Agenda Date: July 11, 2024
Item Number: E2

Docket: PG-240360
Company Name: Cascade Natural Gas Corporation

Recommendation

Figure 3: Overall view of the existing CNGC pipelines.

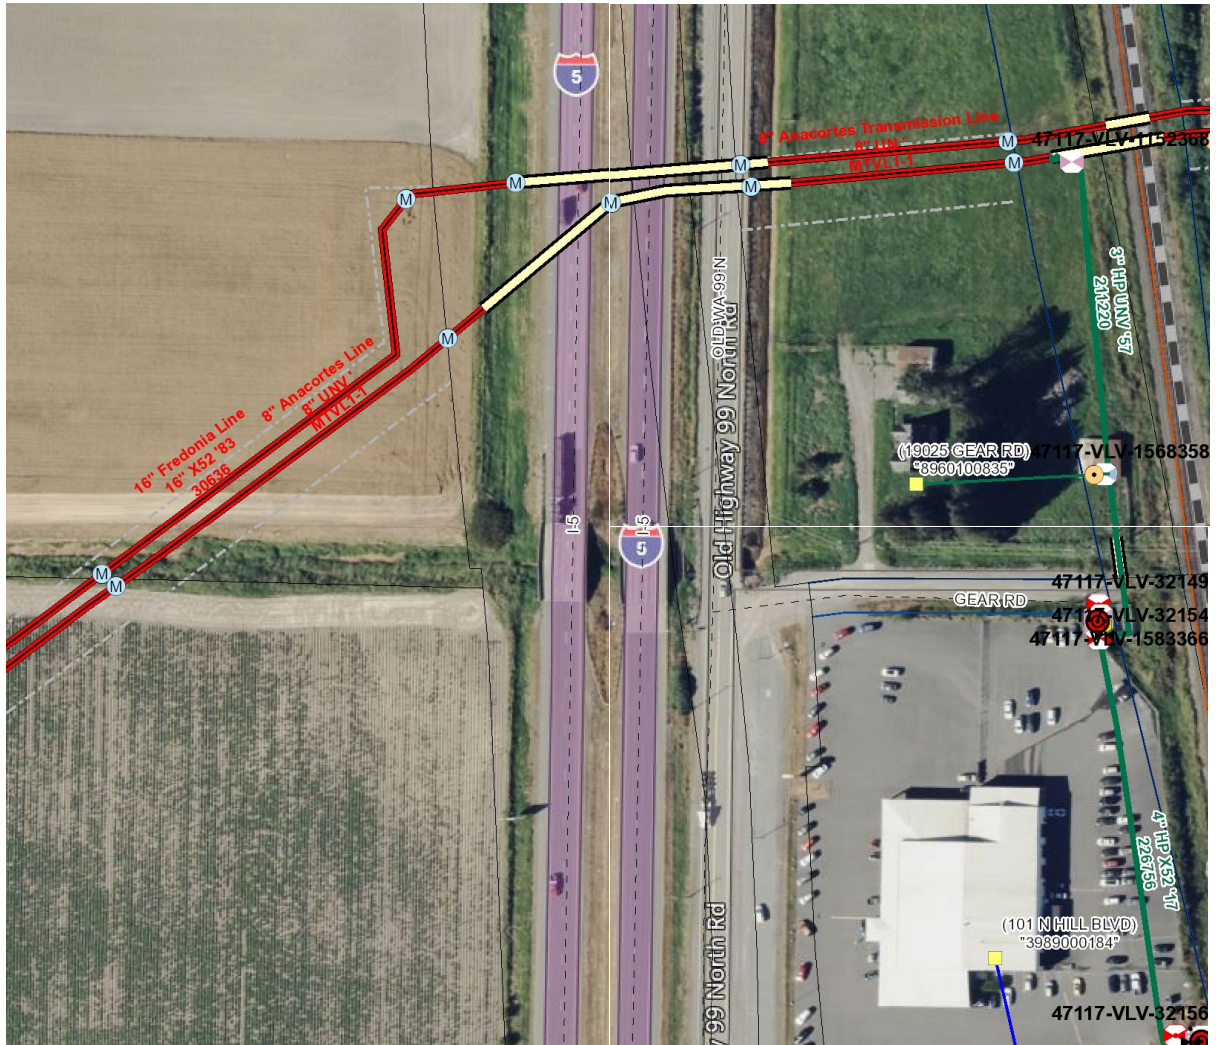
Cascade is proposing to construct and operate 1,041 feet of new 4-inch diameter steel pipeline with an MAOP of 500 psig tying into existing pipelines on the east and west sides of Interstate-5 (Appendix A). The proposed alignment of this new pipeline will be within 100 feet of 2 existing buildings along Gear Rd. in Burlington, Washington as shown in Appendix A. Cascade is performing this work to satisfy Settlement Agreement Docket PG-150120, and to maintain core customer needs.

Figure 4: Route alternatives.

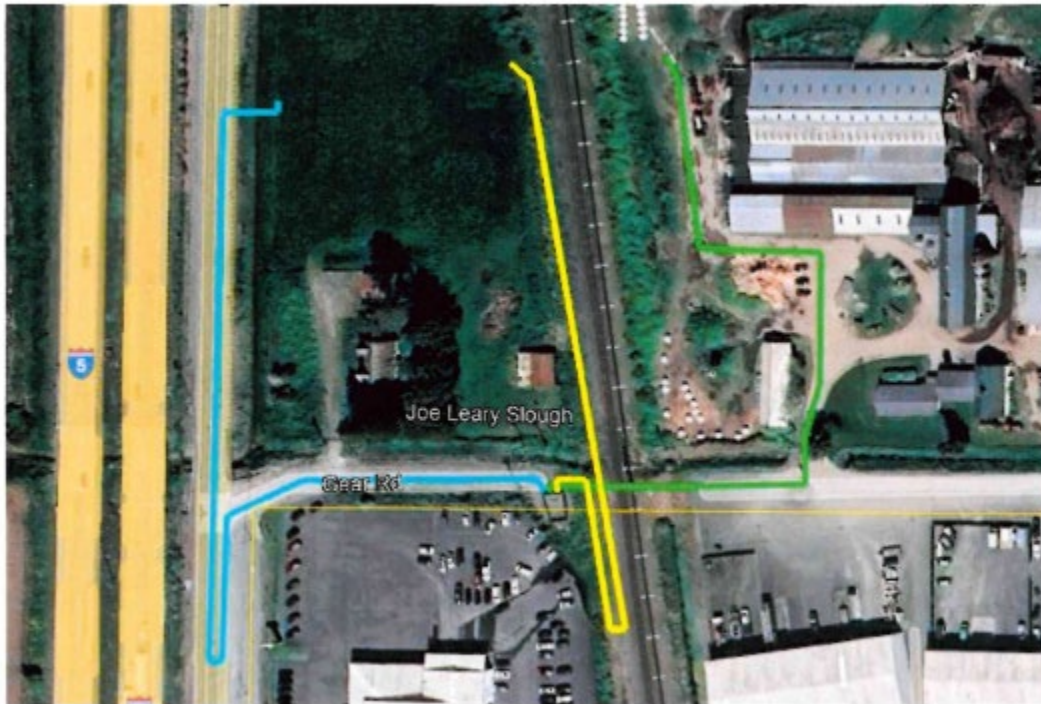
Cascade looked at connections using alternative routes as detailed in Appendix B. These routes were not chosen because of lack of existing easements, difficulty in obtaining new easements, restrictions in place on crossing BNSF Railway tracks, and wetland disturbance that construction would have created. Commission staff (Staff) reviewed the proposed proximity request and calculations. As the pipeline will be new, there are no existing records to review. Staff notes the following facts:
